City of Rome
Department of Public Works
Rome, New York 13440

Subject: City of Rome Railroad Street Interceptor Upgrades Project
RFB-2022-023

ADDENDUM NO. 1

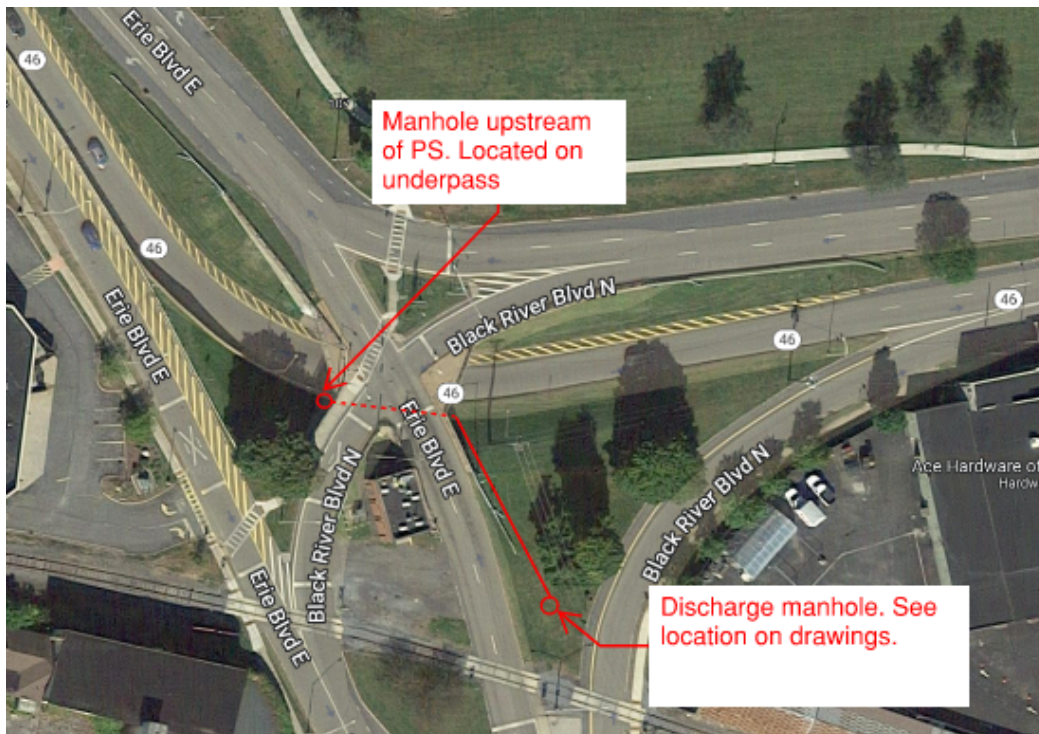
Q16: Project plan sheets C-1 and C-2, approximate stations 1+50 to 6+00, depict the proposed sewer forcemain crossing to the north of the existing “1 Sty. Steel Bldg.” This crossing appears to be through an existing parking lot, yet, project plan sheet C-28, Paving Plan I, does not depict any pavement reconstruction along those stations. Could the Owner please clarify the pipe trench restoration requirements between stations 1+50 and 6+00 and where that restoration is to be measured and paid?

A16: The paving plans on sheets C-28 and C-29 indicate the areas where the road should be restored with full depth pavement or milled and paved across the entire width of the roadway. Pipe trenches outside the shaded areas on C-28 and C-29 shall be restored in accordance with Detail E on CD-1. Trench restoration is included in the pipe bid item. Specific to the stations indicated above, this work is part of Item 22.

3.5 Figure 11219.1 – Pump and System Curve

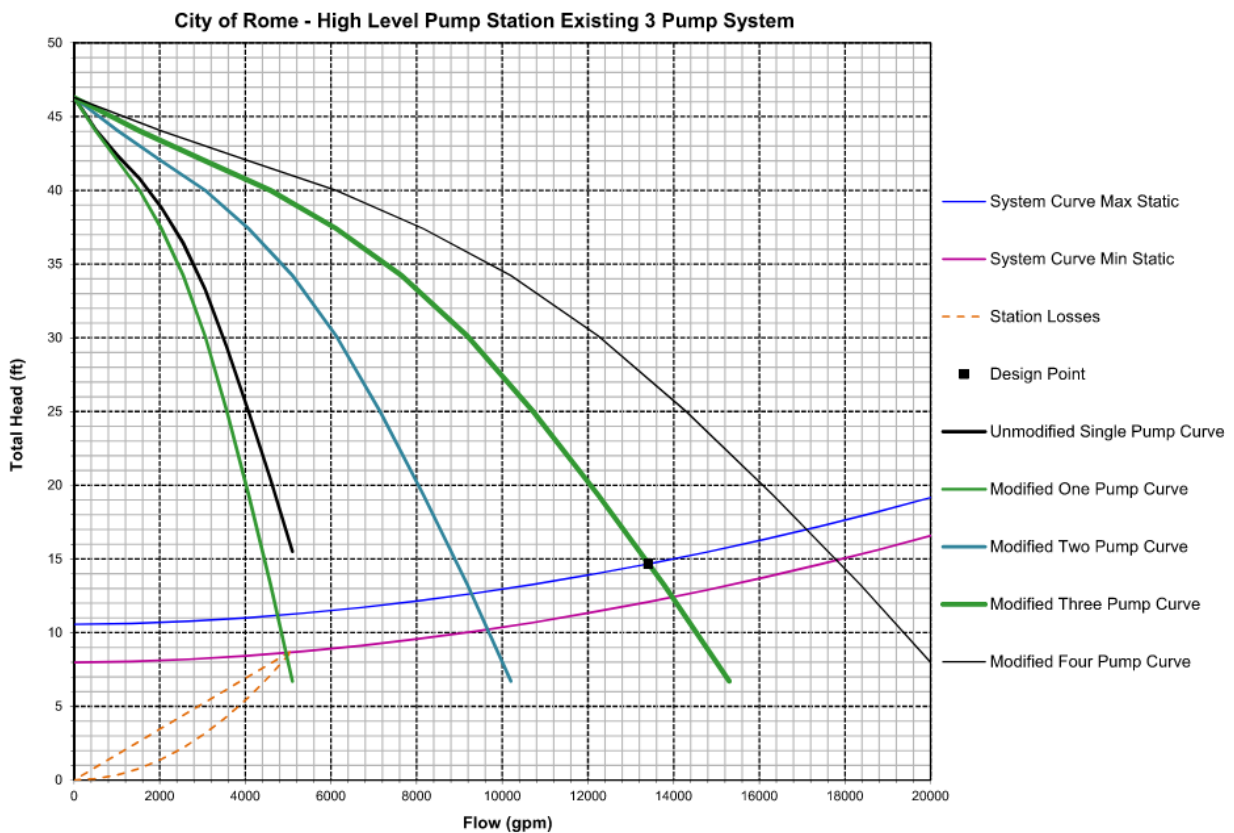
Section 11219 Submersible Solids Handling Pumps

Replace entire specification with specification attached to this document.
